July 6, 2011  
U7-C-NINA-NRC-110097  
10 CFR 2.390

South Texas Project  
Units 3 and 4  
PROJ0772

Responses to Request for Additional Information

Reference: Letter from Tekia Govan to Mark McBurnett, "Request for Additional Information Re: South Texas Project Nuclear Operating Company Topical Report (TR) WCAP-17116-P Revision 0, Supplement 5 – Application to the Advanced Boiling Water Reactor (TAC NO. RG0007)", March 14, 2011 (ML110730488)

Figure 39-e-19 Flow paths in a GE/KWU reactor core.

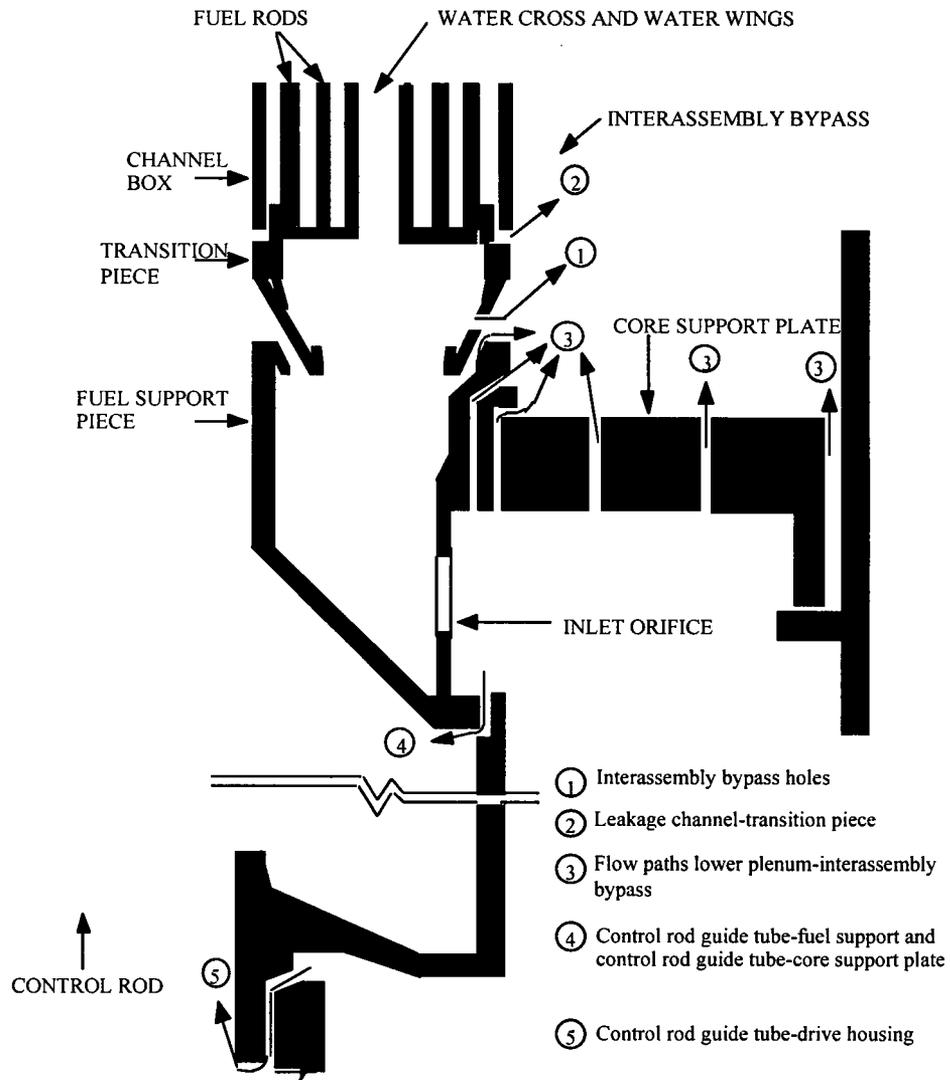
- **Inlet nozzle geometry including orifice loss coefficient, local losses, and flow areas (if these differ for central and peripheral assemblies, provide both sets)**

Flow paths are given in Figure 39-e-19 and areas, loss coefficients etc. are given in Tables 39-e-1 and Table 39-e-2.

Leakage through path 2 above is zero in all SVEA-96 fuel assemblies

Figure 39-e-20 Heat Transfer Coefficient Map.

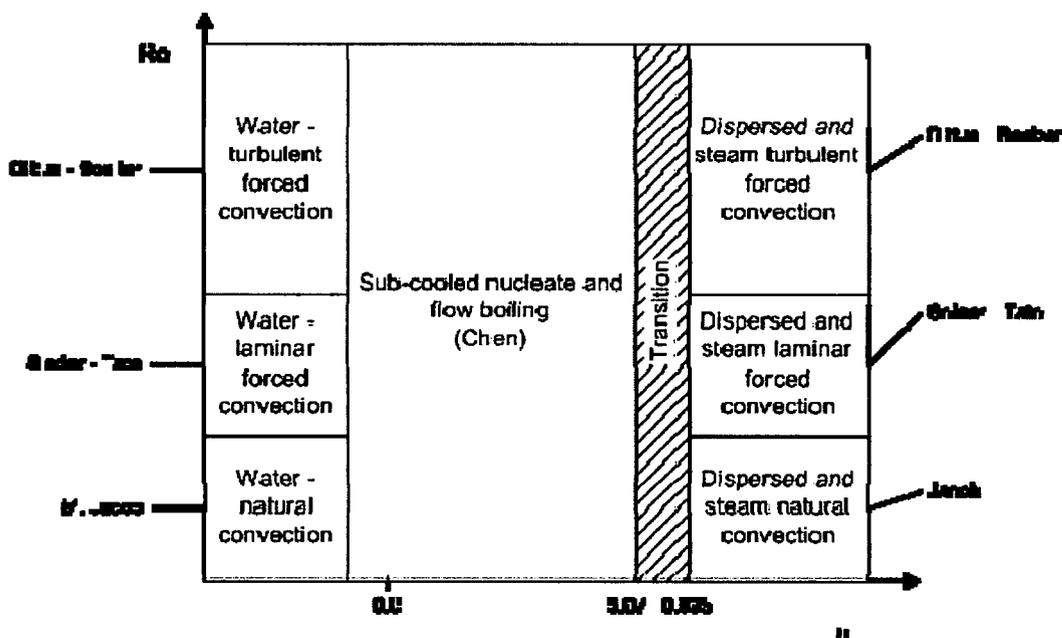
- **Heat transfer coefficient between the channel box outer wall and the bypass**

Using GOBLIN the heat transfer coefficient between channel box outer wall and the bypass coolant is based on local conditions in the bypass region as described in Section 3 of Licensing Topical Report RPB 90-93-P-A. The heat transfer coefficient map is shown below in Figure 39-e-20 for a non-dryout situation.
